REVIEW OF LANDSCAPE AND VISUAL IMPACT ASSESSMENT

23/0427/DNS- Twyn Hywel Energy Park Land Noth-West Of Caerphilly

Undertaken by: Richard Bryan CMLI, Landscape Architect (Team Leader) for Caerphilly County Borough Council. Date of Review: August 2023

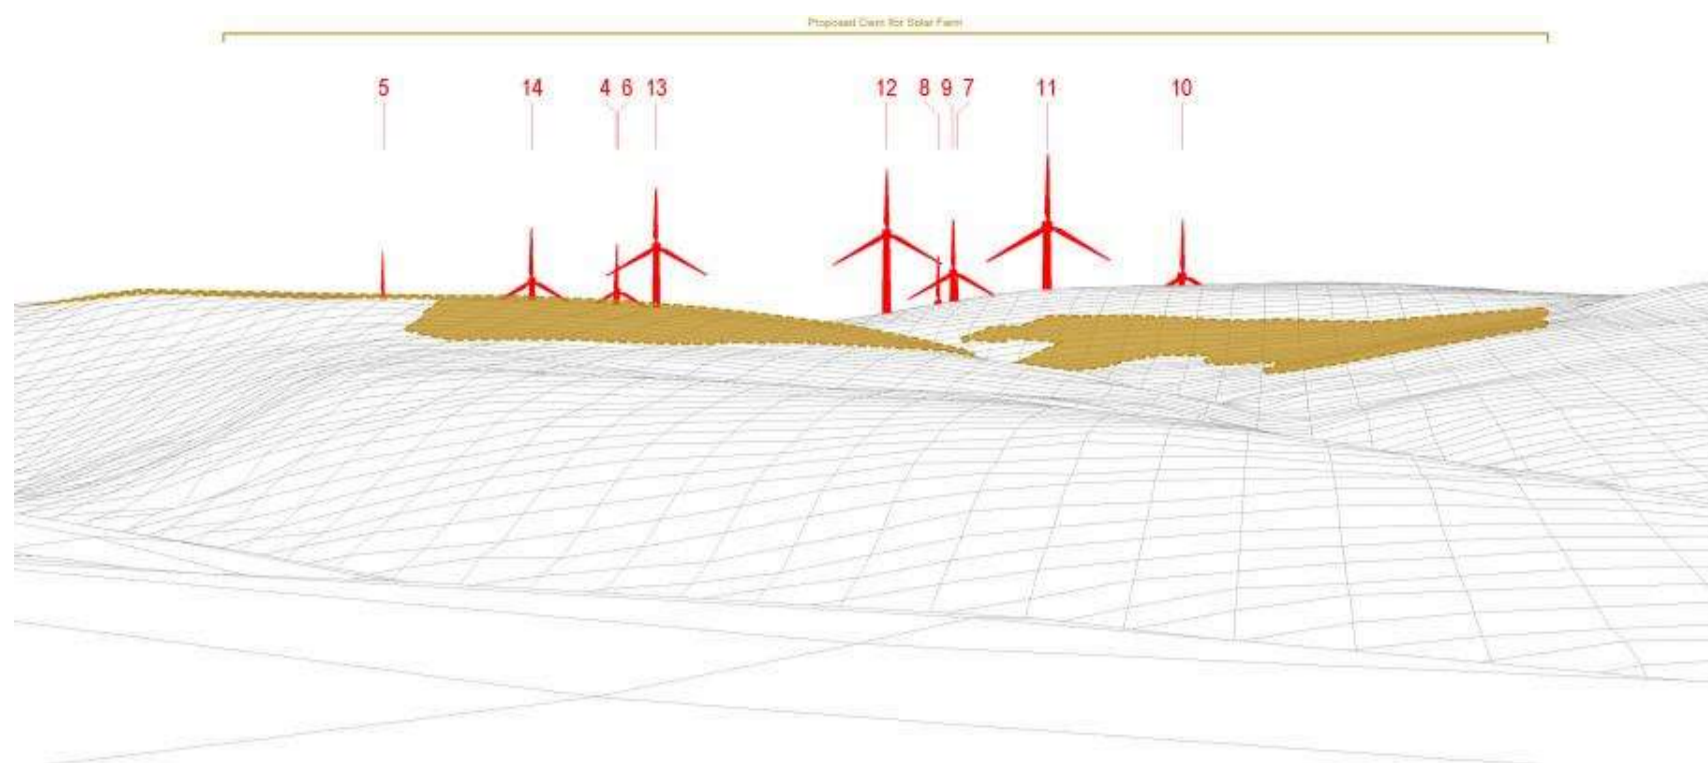
The LVIA adequately considers cumulative impacts, and concur and that there will be no cumulative impacts from other existing or proposed wind farms.
